GEOTECHNICAL INVESTIGATION

TABER RESIDENCE
5720 NORTH HIGHWAY 1
LITTLE RIVER, CALIFORNIA

Project Number 12416.02

RE: Response to Comments, Proposed Taber Residence, 5720 North Highway 1, Little River, Mendocino County, California, CDP 24-2014

Table 1: Sea Level Rise Projections using Year 2000 as the Baseline

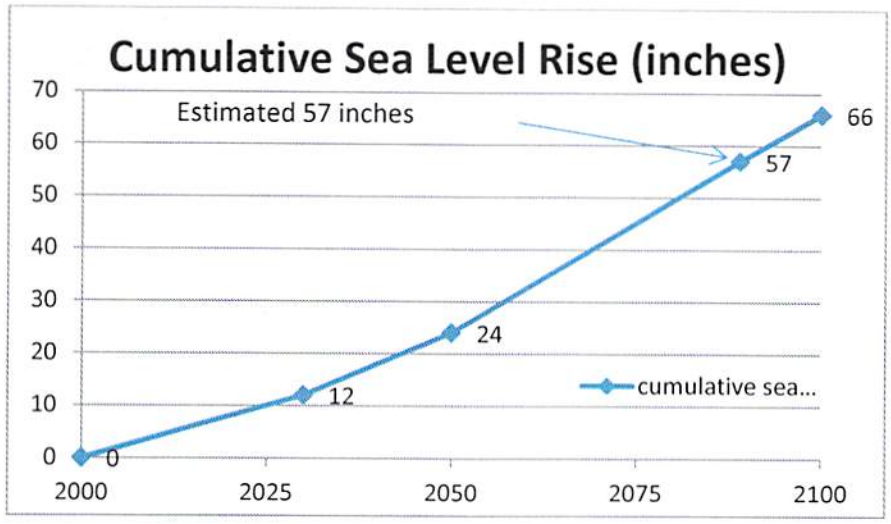
This letter is in response to California Coastal Commission (CCC) comments on your permit application, CDP 24-2014 in their letter dated November 7, 2014. These comments came as a follow-up to our site meeting on July 31, 2014. Brunsing Associates, Inc. (BAI) previously prepared a geotechnical investigation report dated June 11, 2014. The report provided setbacks from the ocean bluff and sea cave walls and stated that building a bridge over the sea cave to support a house was feasible.

Using the CCC's economic lifespan of a building of 75 years, we considered the effects of sea level rise for a structure built circa 2015 through 2090. For this discussion, we have assumed a linear rate of sea level rise (which may or may not be the case) in order to estimate a projected sea level rise of approximately 57 inches (4.75 feet) by 2090.
